HISTORIC AND DESIGN REVIEW COMMISSION

December 15, 2021

HDRC CASE NO: 2021-612
ADDRESS: 2043 W SUMMIT AVE
LEGAL DESCRIPTION: NCB 1942 BLK 30 LOT 11
ZONING: R-6, H
CITY COUNCIL DIST.: 7
DISTRICT: Monticello Park Historic District
APPLICANT: Louanne (Ann) Hardee/HARDEE CHARLES R & LOUANNE
OWNER: Louanne (Ann) Hardee/HARDEE CHARLES R & LOUANNE
TYPE OF WORK: New construction of a garage/carport
APPLICATION RECEIVED: November 21, 2021
60-DAY REVIEW: Not applicable due to City Council Emergency Orders
CASE MANAGER: Rachel Rettaliata

The applicant is requesting a Certificate of Appropriateness for approval to construct an accessory structure in the rear yard.

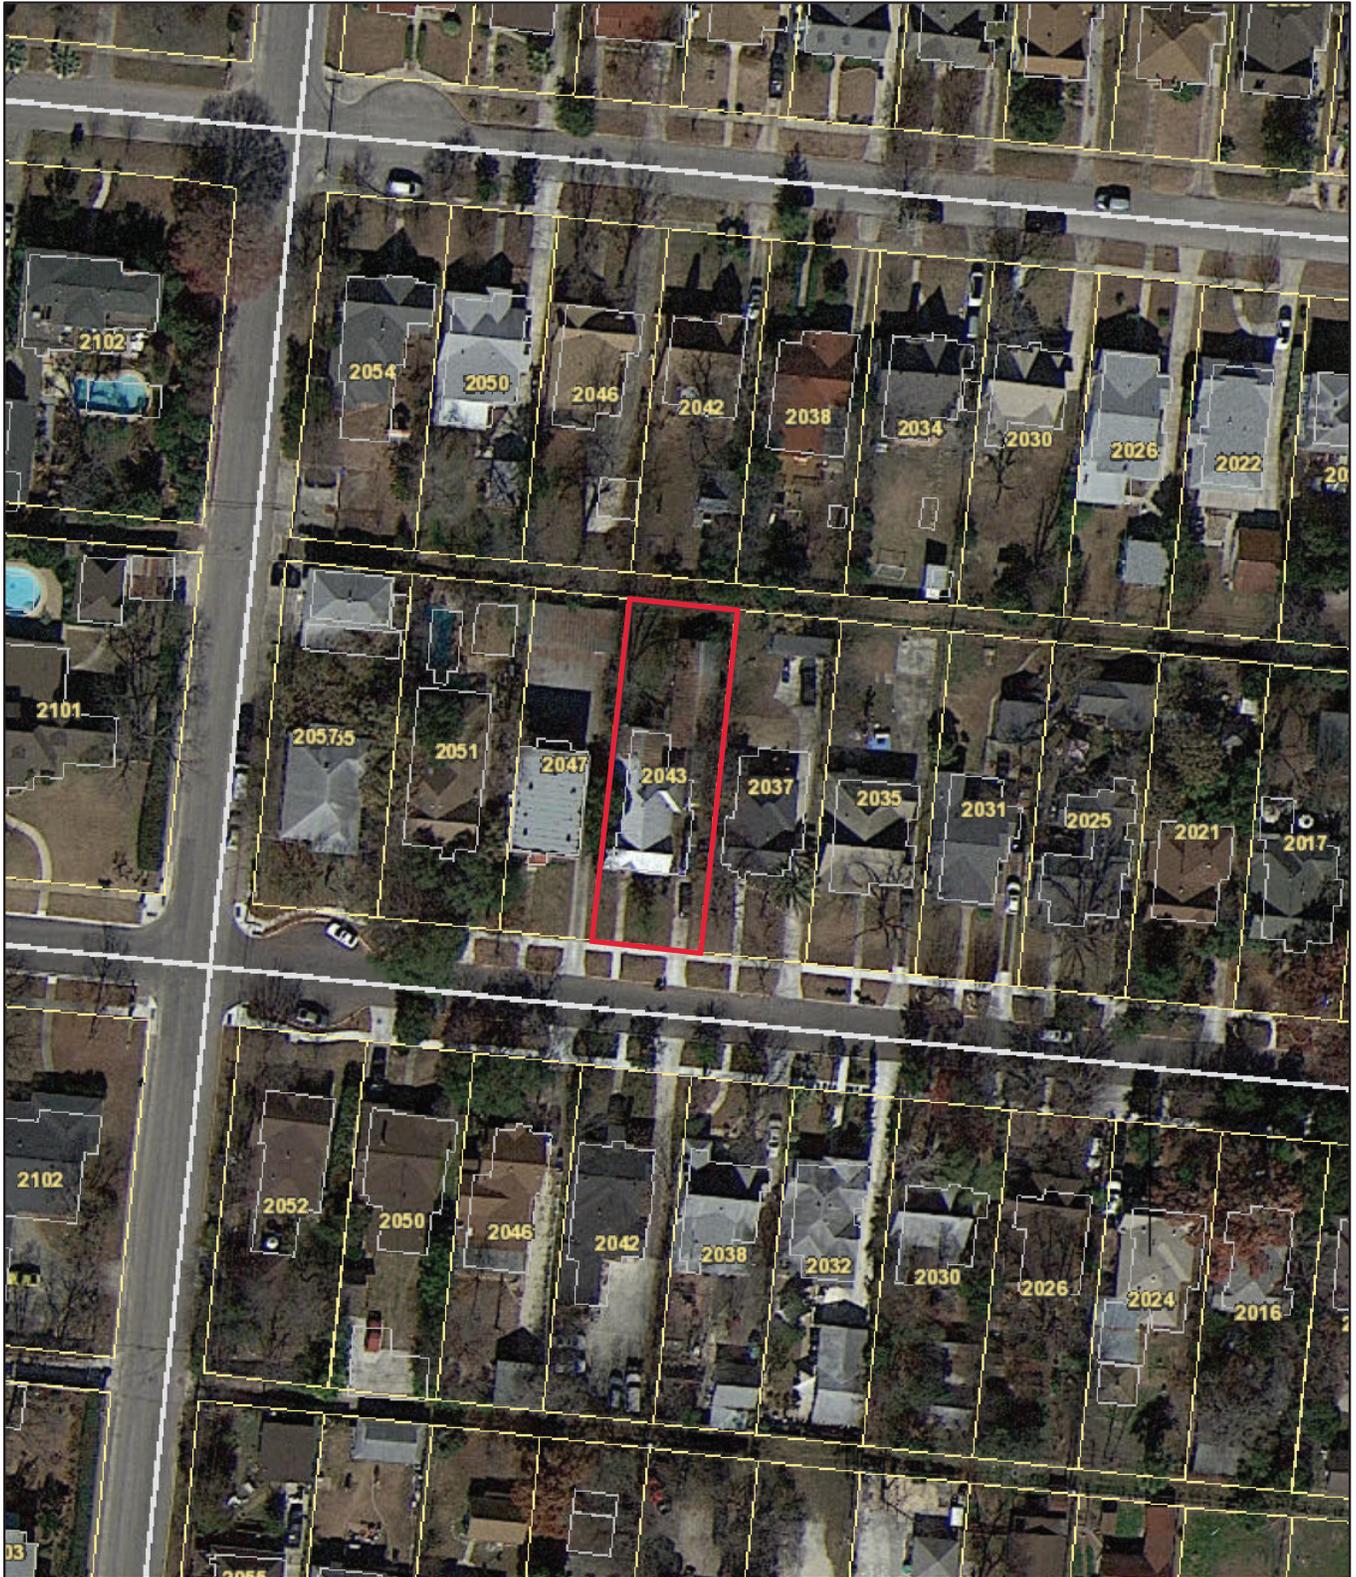
- c. **NEW REAR ACCESSORY STRUCTURE: ORIENTATION** – The applicant has proposed to install a 36-foot by 20-foot front gable steel accessory structure with attached carport on the replacement concrete slab at northeast side of the property, in the same location as the previously existing rear accessory structure. The proposed rear accessory structure will be oriented toward W Summit, matching the orientation of the previous accessory structure. Guideline 5.B.i for New Construction states that applicants should match the predominant garage orientation found along the block. Do not introduce front-loaded garages or garages attached to the primary structure on blocks where rear or alley-loaded garages were historically used. The applicant has provided evidence that the proposed structure will match the predominant orientation on the block. Staff finds the proposal appropriate.

- d. **NEW REAR ACCESSORY STRUCTURE: MASSING AND FORM** – The applicant has proposed to install a 36-foot by 20-foot front gable steel accessory structure with attached carport. The proposed accessory structure is 11 feet in height and is designed to match the previous accessory structure, featuring a front gable roof with a boxed eave and a front carport. According to Guideline 5.A.i. for New Construction, new garages and outbuildings should be designed to be visually subordinate to the principal historic structure in terms of their height, massing, and form. Guideline 5.A.ii. for New Construction states that new outbuildings should be no larger in plan than 40 percent of the principal historic structure footprint. Staff finds the proposal consistent with the Guidelines.

- e. **NEW REAR ACCESSORY STRUCTURE: MATERIALS** – The applicant has proposed to install a rear accessory structure constructed of steel, featuring a metal roof, metal siding, steel post supports, and a solid door. The applicant has provided photos of similar rear accessory structures in the district that match in location, form, and material. According to Guideline 3.A.i. for New Construction, materials that complement the type, color, and texture of materials traditionally found in the district should be used on new construction. Materials should not be so dissimilar as to distract from the historic interpretation of the district. For example, corrugated metal siding would not be appropriate for a new structure in a district comprised of homes with wood siding. Guideline 5.A.iii. for New Construction states that new outbuildings must relate to the period of construction of the principal building on the lot through the use of complementary materials and simplified architectural details. The rear accessory structure will match the existing color palette of the primary structure but will be constructed of steel and metal cladding. Staff finds the proposed materials inconsistent with the Guidelines. A rear accessory structure of wood construction with wood or Hardie siding would be appropriate.

- f. **NEW REAR ACCESSORY STRUCTURE: MATERIALS: DOORS AND WINDOWS** – The applicant has proposed to install a rear accessory structure that features a solid door. At this time, applicant has not submitted material specifications for the proposed door. The proposed structure does not feature windows. Guideline 5.A.iv for New Construction states that window and door openings should be designed to be similar to those found on historic garages or outbuildings in the district or on the principle historic structure in terms of their spacing and proportions. Staff finds that the applicant should submit final door specifications to staff for review.

- i. That the carport columns be wood, or wood wrapped, and be no wider than 6”x6”.
- ii. That the structure feature wood siding or smooth Hardie board siding with a reveal of no more than 6 inches based on finding e.
- iii. That the applicant submits final material specifications and updated plans to staff for review and approval prior to the issuance of a Certificate of Appropriateness.
- iv. That the applicant submits final material specifications for the proposed door to staff for review and approval prior to the issuance of a Certificate of Appropriateness based on finding f.
- v. That the applicant meets all setback standards as required by city zoning requirements and obtains a variance from the Board of Adjustment if applicable.
